EDINBURG CITY COUNCIL
CITY OF EDINBURG, HIDALGO COUNTY, TEXAS

AGENDA ITEM AND RECOMMENDATION SUMMARY
CITY COUNCIL SPECIAL MEETING
MAY 26, 2016

Consider Variance Request to the City's Unified Development Code as Follows: Article 7 - Plat and Site Plan Design and Article 8 - Streets, Utilities, and Drainage, for Terry Palms Subdivision No. 3, Being a 4.49 Acre Tract of Land out of Lots 1 & 2, Block 39, Santa Cruz Gardens Unit No.2, Located on the West Side of Terry Road, North of Ramseyer Road, as Requested by Quintanilla, Headley and Associates, Inc. (*Motion Required to Remove from Table. This Item was Tabled at the May 03, 2016 City Council Meeting.*) [Jesus R. Saenz, Director of Planning & Zoning].

Consider Variance Request to the City's Unified Development Code as follows: Article 3 - District and Bulk Standards, for Mon Mack Village Subdivision, being a 1.00 acre tract of land out of Lot 13, Section 276, Texas-Mexican Railway Company Survey, located on the Northeast corner of Sprague Road and Mon Mack Road, as requested by J & R Engineering. [Jesus R. Saenz, Director of Planning & Zoning].

TERRY PALMS
SUBDIVISION NO. 3

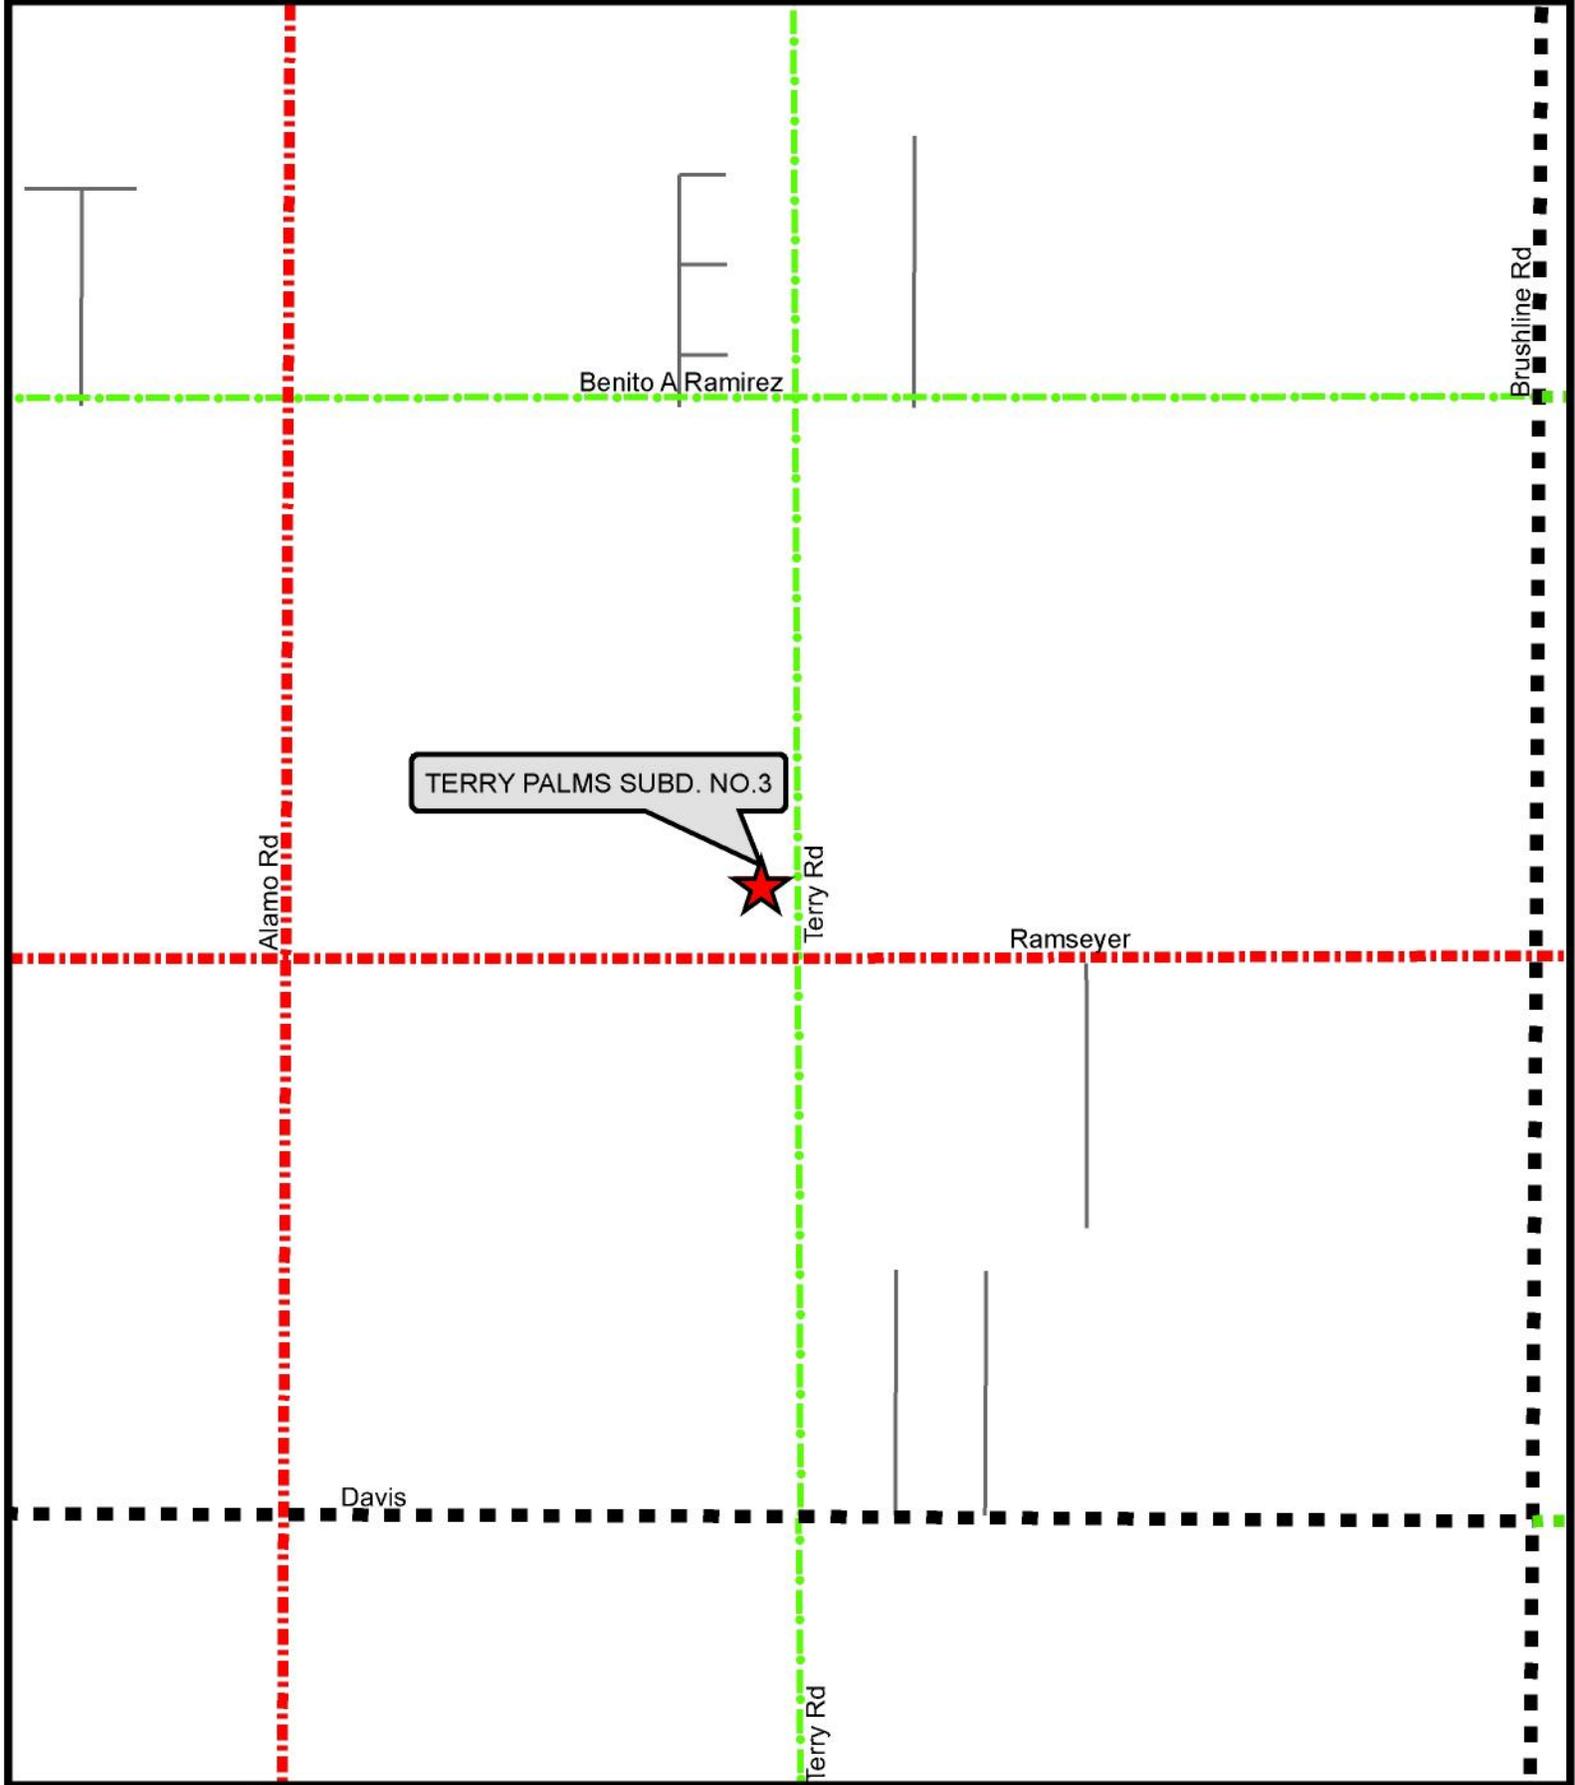
Variance Request: For Lots width at 83.8-feet less than 100-feet as required, with lots proposing a 40 foot front setback.

Variance Request: Pavement section of seventeen and one half (17.5) feet for Terry Road to remain with consideration of widening and pavement section of twenty nine and one half (29.5) feet for Ramseyer Road to remain with consideration of widening.

Variance Request: Installation of the 5-foot sidewalk on Terry Road and Ramseyer Road.

Staff recommends the development comply with the UDC Article 8, Table 8.204 – Street Standards requiring Terry Road, a collector street widening portion of seventeen and one half (17.5) feet and Ramseyer Road a principal arterial street widening portion of twenty nine and one half (29.5) feet. In lieu of widening street, the developer will be required to escrow funds to be used on a future widening of Terry Road and Ramseyer Road.

Since this Subdivision is located within the City’s ETJ, Staff recommends a general plat note requiring lot owners to install a 5-foot concrete sidewalk at building permit stage.

Staff recommends Denial of the Variance Requests.

MON MACK VILLAGE
SUBDIVISION

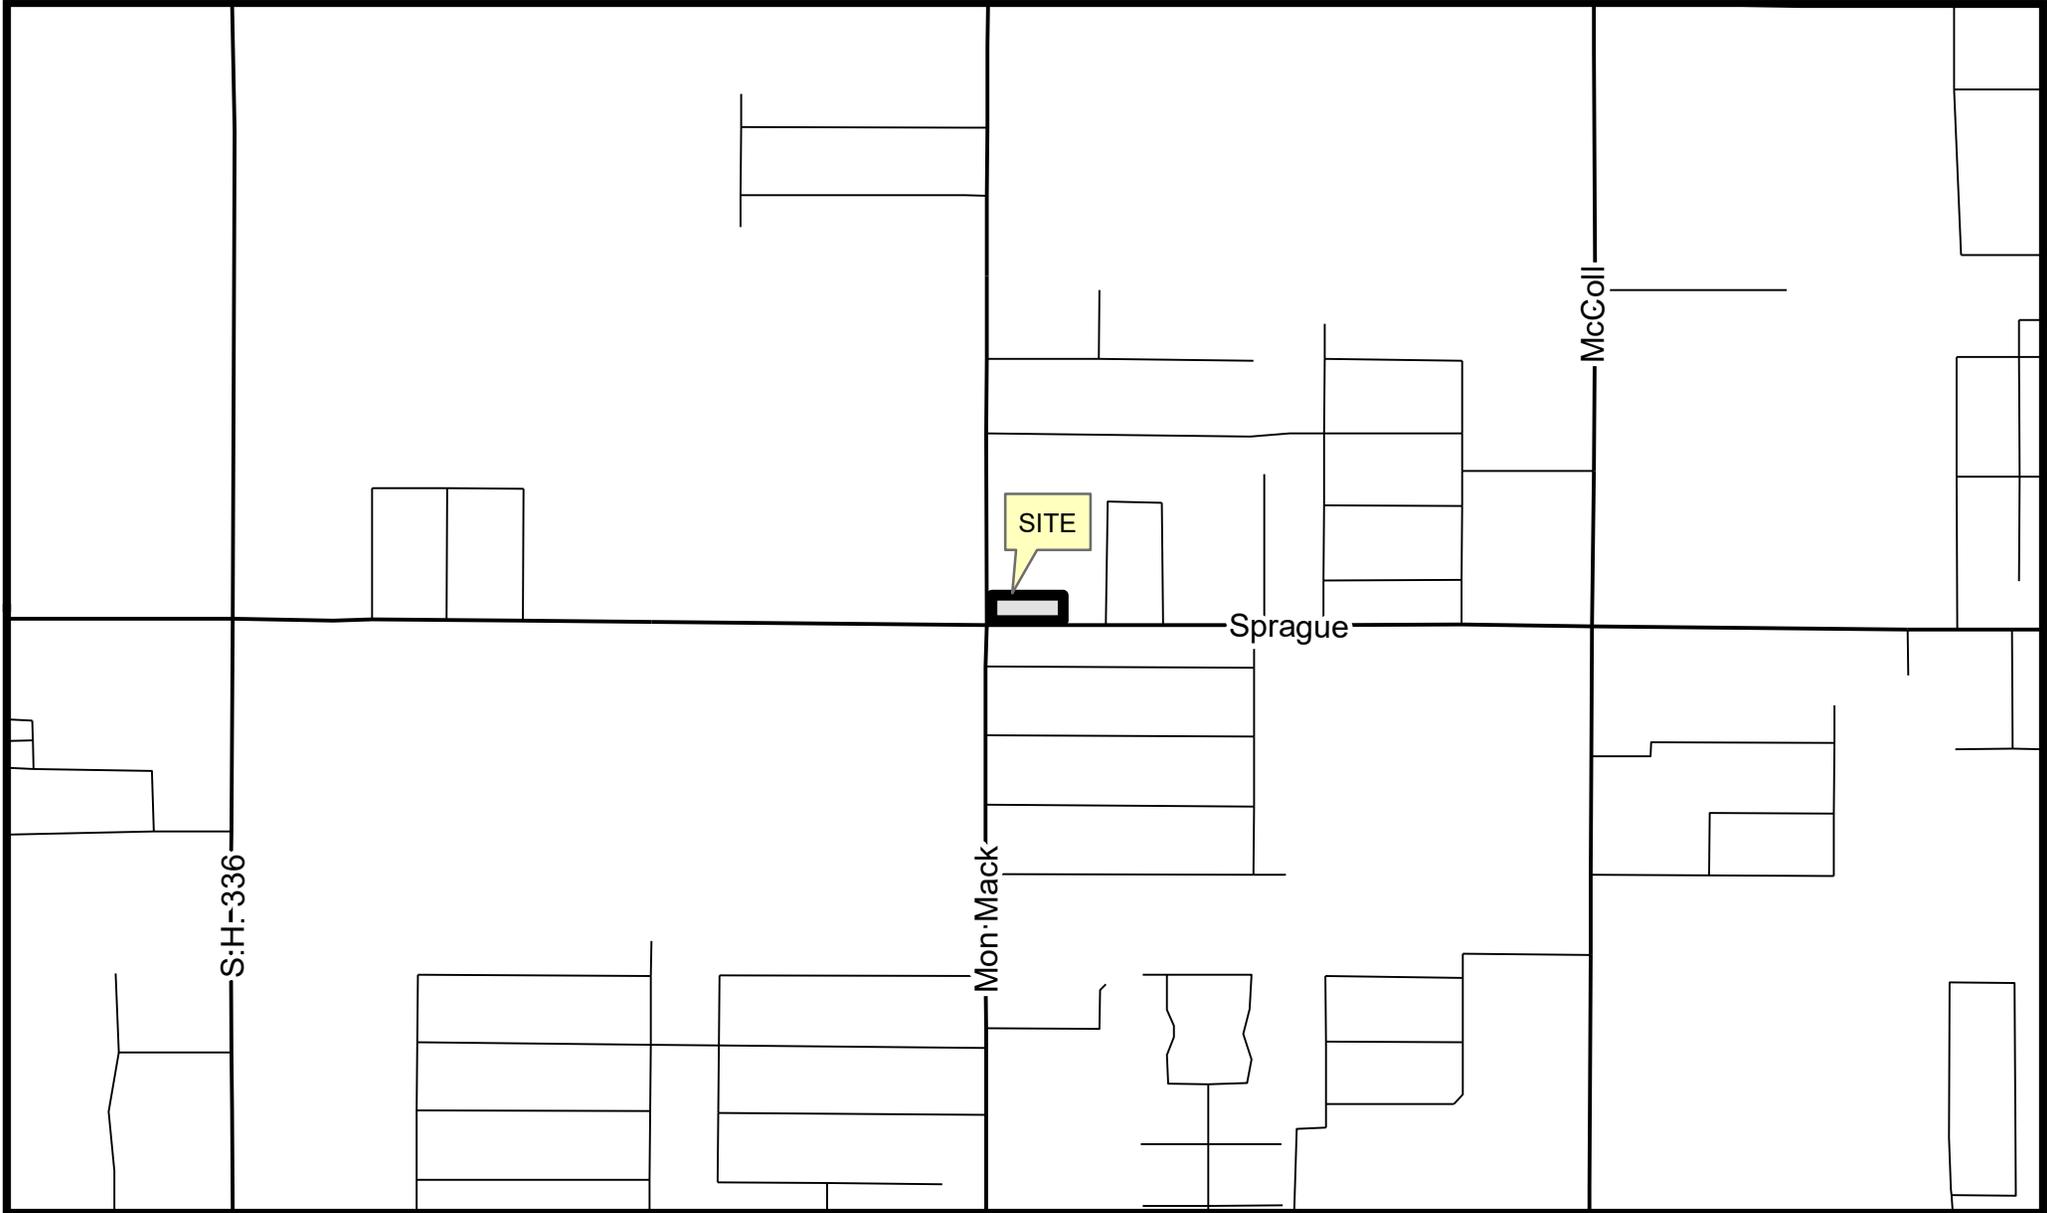
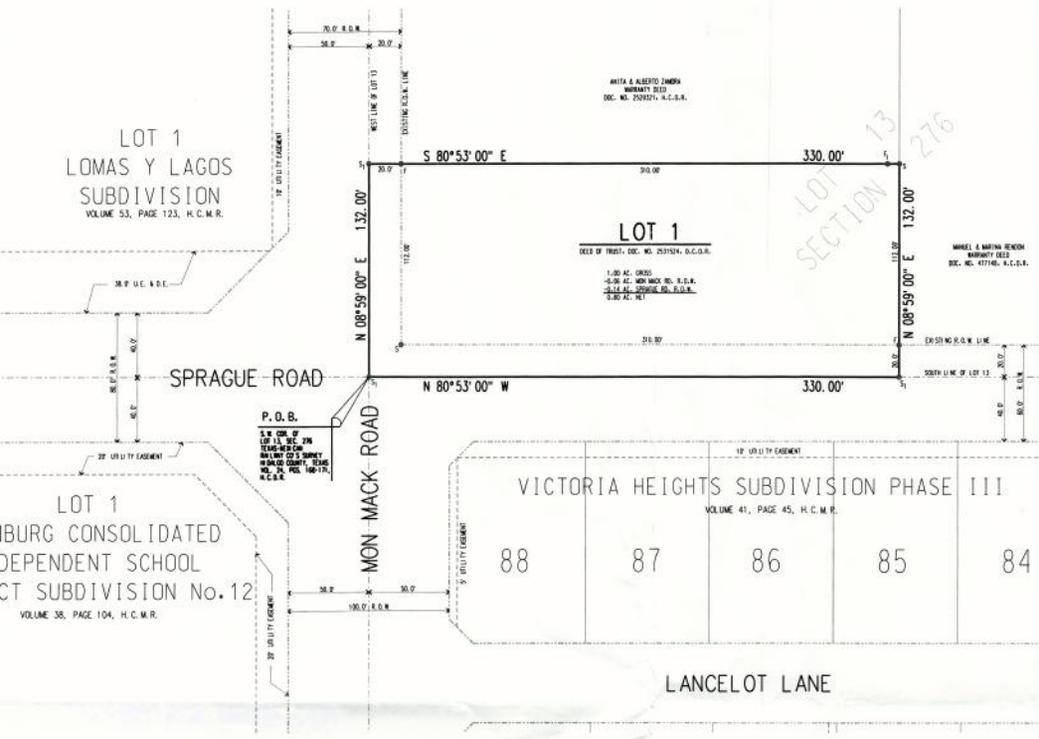
Variance Request: To consider reducing the rear setback to 10-feet from a 30-foot rear setback as required by code.

Staff Recommends denial of this Variance Request. Staff recommends the Engineer/Developer comply with setback as required by code.
